NUREG-1949, Vol. 3

# **Safety Evaluation Report Related to Disposal of High-Level Radioactive Wastes in a Geologic Repository at Yucca Mountain, Nevada**

Volume 3:  
Repository Safety After  
Permanent Closure

**Figure 6-1. Potential Flow Pathways in the Engineered Barrier System (SAR Figure 2.3.7-8; DOE, 2008ab)**

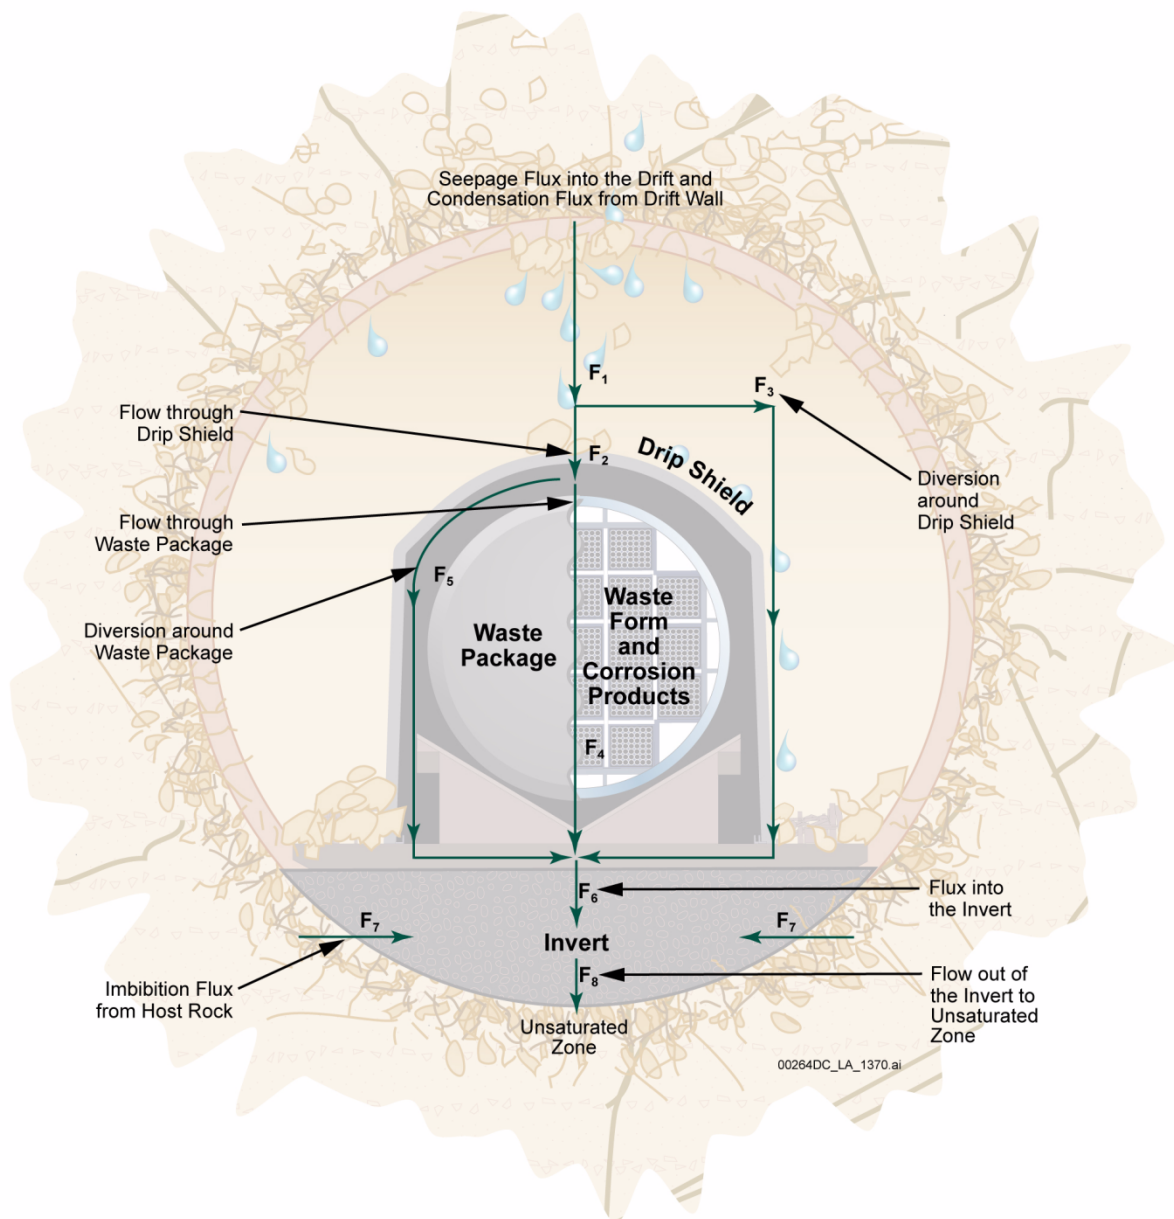
The applicant described the flow pathways and flux rates (F1–F8) in the EBS flow abstraction as follows (Figure 6-1): the F1 flow path accounts for the total dripping flux from a drift wall. The total dripping flux is the sum of the seepage flux from the drift wall above and the condensed water on drift walls (SER Section 2.2.1.3.6.3.4); these are direct inputs to the EBS flow abstraction. The F2 flow path accounts for the flux through partially failed patches of the drip shield formed by general corrosion. Localized corrosion of the drip shield is excluded from the performance assessment, as discussed in SER Section 2.2.1.2.1.3. The F3 flow path accounts for the diversion of flux around the drip shield (computed as  $F3 = F1 - F2$ ), which will drain directly into the invert. Although the diversion of flux around the drip shield is included in the construction of the EBS flow model, the applicant did not implement the flux-splitting algorithm for drip shields in TSPA simulations, because the drip shields were modeled to be either all intact or failed, as described in SNL (2007aj, Section 6.1.1). The F4 flow path accounts for the flux through patches, formed as a result of general corrosion of the outer barrier of the waste packages. Localized corrosion of the outer barrier of waste packages is not considered

important by DOE for this abstraction, because the probability of waste package breach by localized corrosion is low in DOE's model (SER Section 2.2.1.3.1.3.1). The  $F_5$  flow path accounts for the diversion of flux around waste packages (computed as  $F_5 = F_3 - F_4$ ), which will drain directly into the invert. The  $F_6$  flow path is the total flux entering the invert (computed as  $F_6 = F_4 + F_3 + F_5$ ). The  $F_7$  flow path accounts for the imbibition flux from the host rock matrix into the invert and is a direct input to the EBS flow abstraction. The  $F_8$  flow path is the total flux from the invert to the unsaturated zone (computed as  $F_8 = F_6 + F_7$ ). Thus, the magnitude of fluxes in the EBS is determined by the flux rates at the drift wall, flow exchanges between the invert and the surrounding unsaturated fractured domain, and the size
